STAFF REPORT

Subject: Letters regarding the Pescadero Road Project

I am writing in response to the CAWD proposal for realignment of the Pescadero Canyon Sewer main. I have been told this proposal dated 2016 is going to be reviewed and voted on at the CAWD Board of Directors meeting on September 29th.

H071 Grinder Pump Station from E/One: Overview

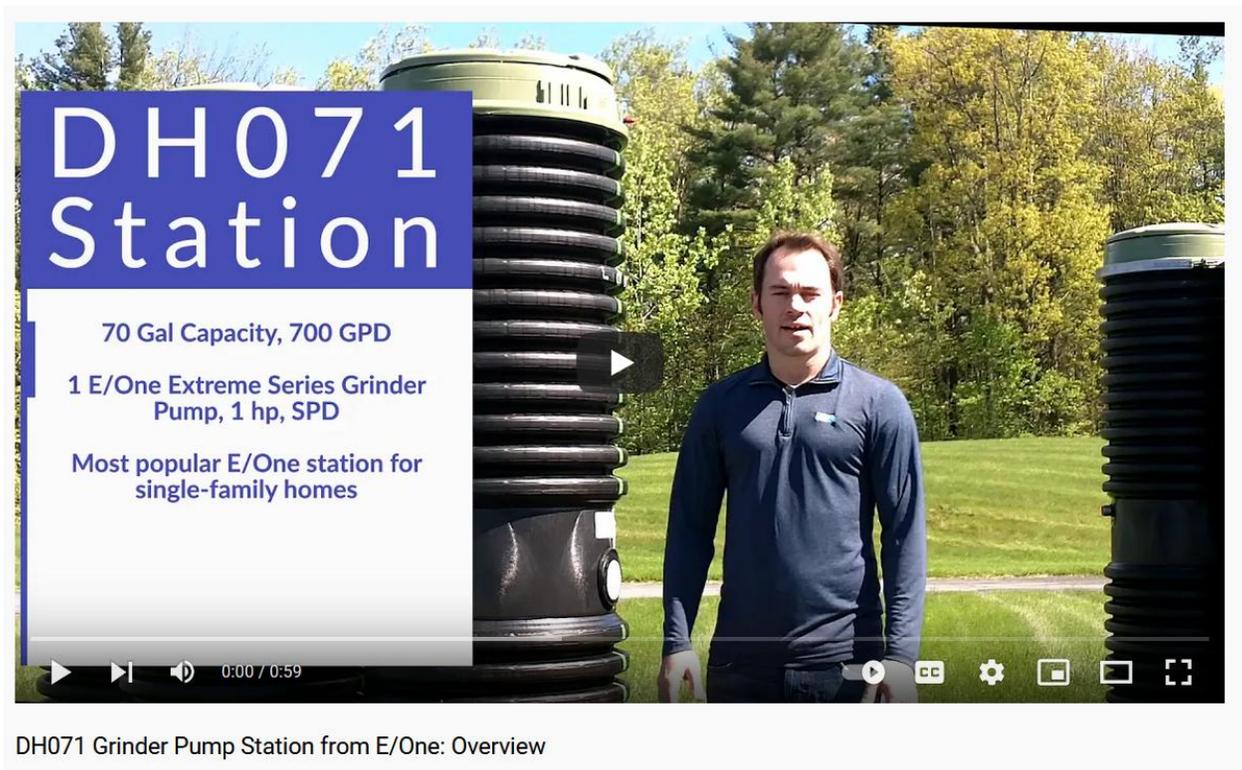
- 1) The report was written in 2015-2016 and thus costing figures are completely out of date. An estimate of \$100,000-\$200,000 per home installation for plan B might be more accurate. Plan A is a more fiscally sound solution.
- 2) This is a very large pump and system that requires heavy machinery to lift and to install. Highly sloped land and difficult to access areas make option B very damaging environmentally, very costly, and expensive to maintain. The environmental damage could be equal or worse with plan B compared to plan A. Note the size of the system and installation equipment and holes required.

Figure 8

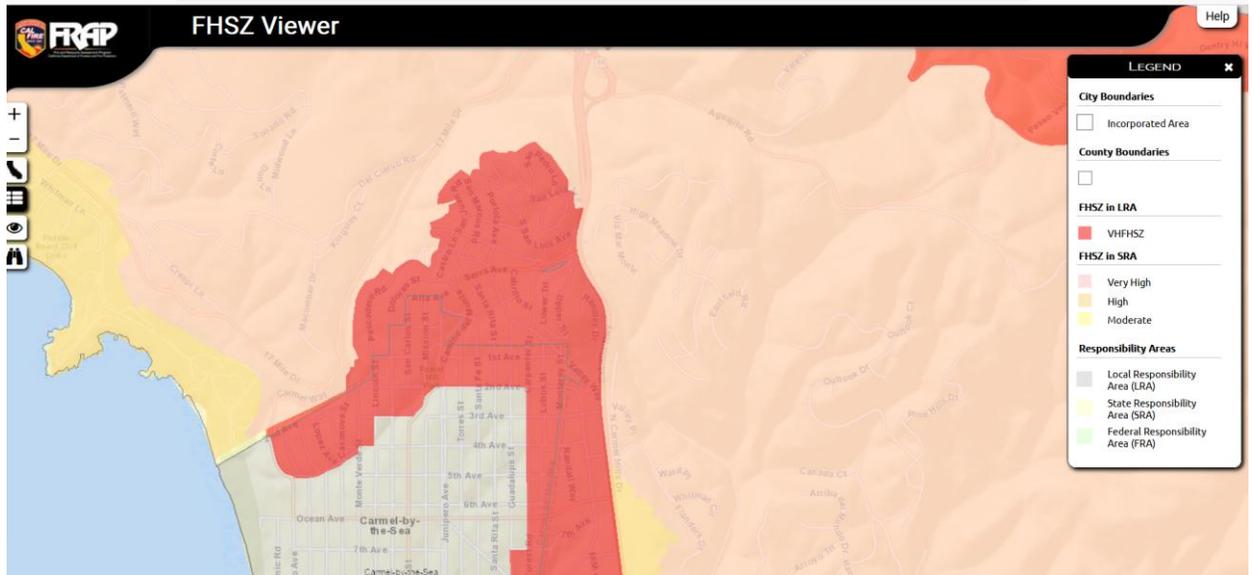
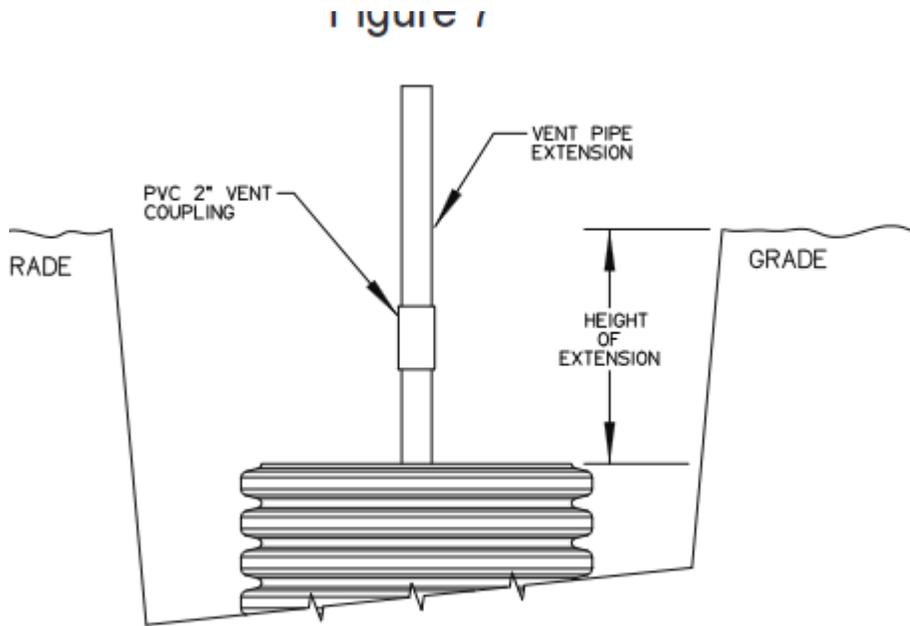
- 3) Based on plan B, the 18 homes where the pumps are to be installed lie within a “VERY HIGH FIRE HAZARD ZONE”. Installation of these pumps, creates 18 additional sources of combustible gas or potential electrical sparking within a forest area and is extremely dangerous.

- 4) Venting of gases from the pumps at 18 locations along the canyon is dangerous to potential explosion of fumes and degrades the natural elements of the canyon with noxious fumes. Venting of the pumps would, per the engineering specifications, be placed almost directly in the forest area close to animals, flora, and gardens.

Figure 4

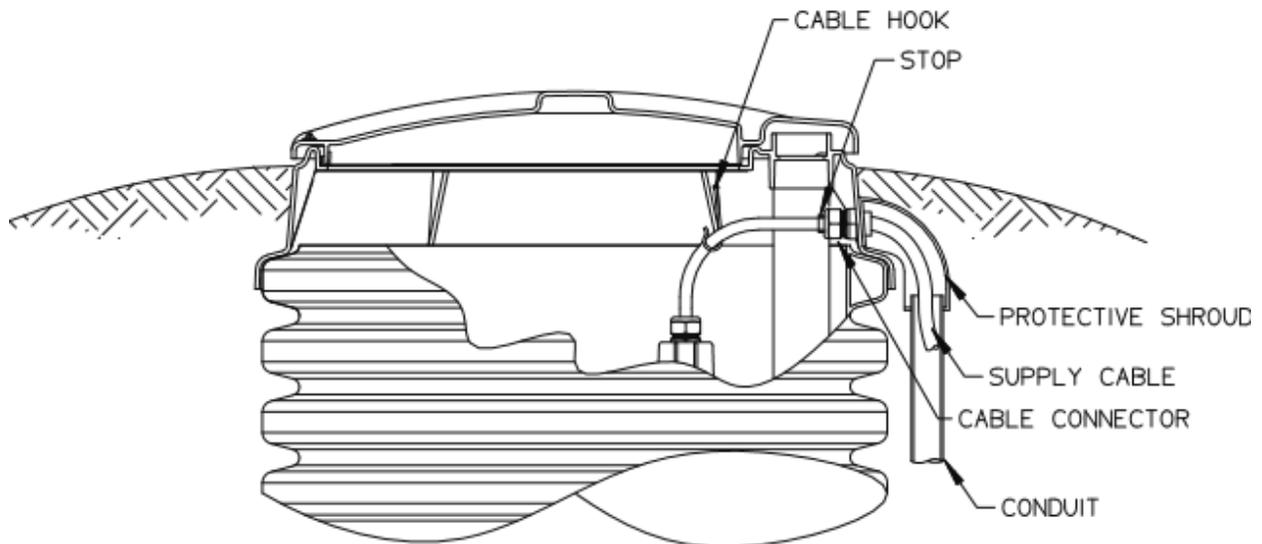
- 6) Due to the high grade slopes of the land and the large lots, long electrical lengths would be required and thus 240V power would have to be delivered to the pumps; high voltage can further create fire hazards versus lower power and voltage options.

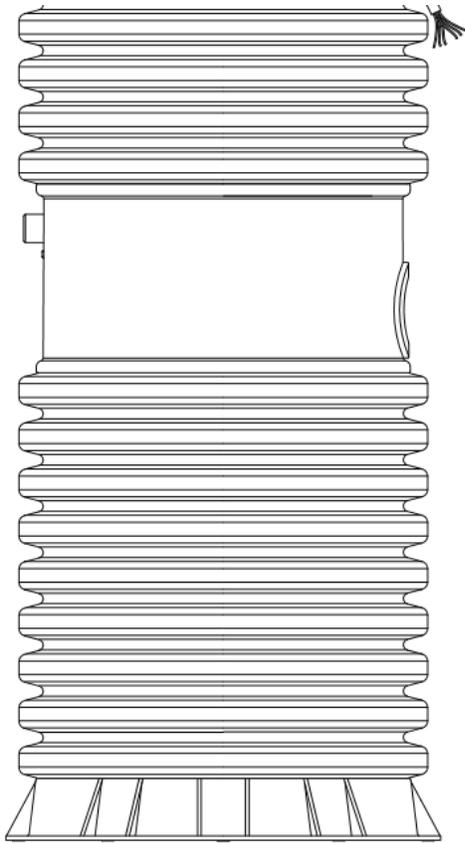
- 9) Warranty periods for pumps in Plan B are short and replacement places a very large burden on home owners.

**FIGURE 3: ALTERNATIVE B - ROADWAY ALIGNMENT
PESCADERO ROAD SEWER REPLACEMENT PROJECT
CARMEL AREA WASTEWATER DISTRICT**

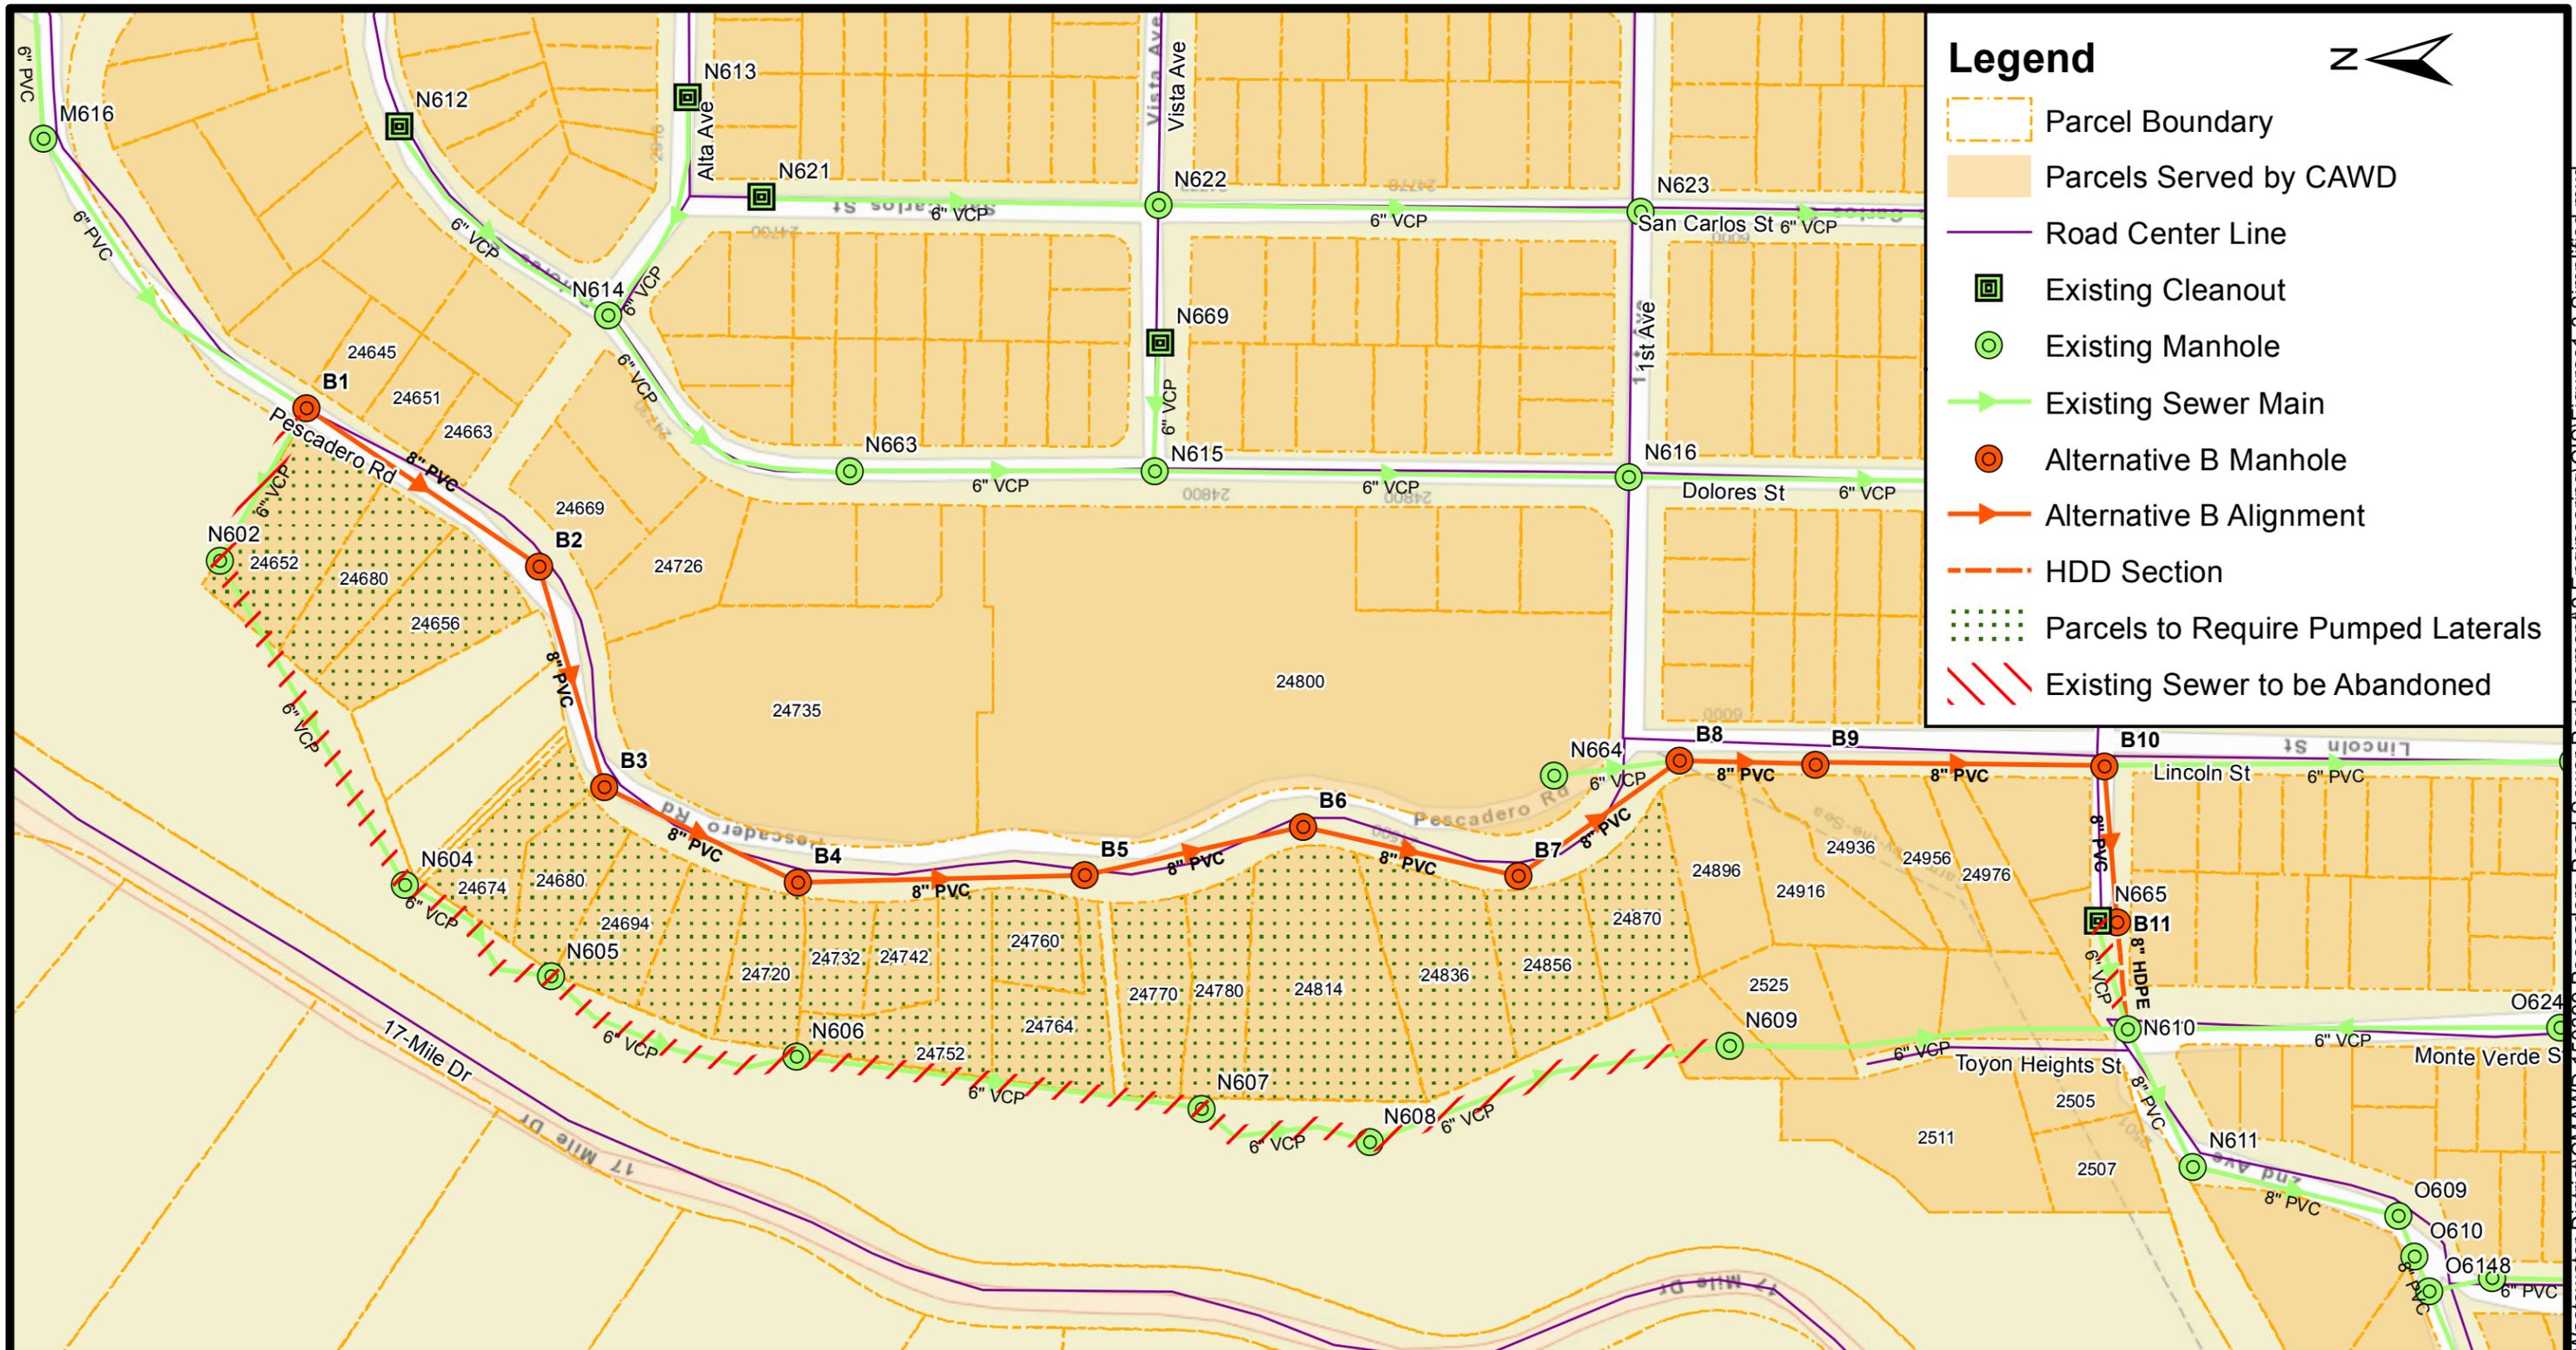
Plan B is to run a new sewer main under Pescadero Road.

Plan B will require 23 homes to install sewer grinder pumps below each home in the canyon with new private lateral piping to push the sewage uphill to the new sewer main.

CAWD at this point states they favor Plan B because although they estimate that it will cost 50% more than plan A, their initial assessment is that it will avert environmental damage to the protected Pescadero Canyon area by keeping heavy equipment out of the canyon.

While perhaps true in a limited sense, there are potential serious adverse environment and financial consequences from Plan B which are not addressed.

CAWD mandates compliance with and will reimburse the installation costs for each of the 23 impacted homes as part of their plan. This makes the environmental impact at each of those home sites an integral part of CAWD's overall plan.
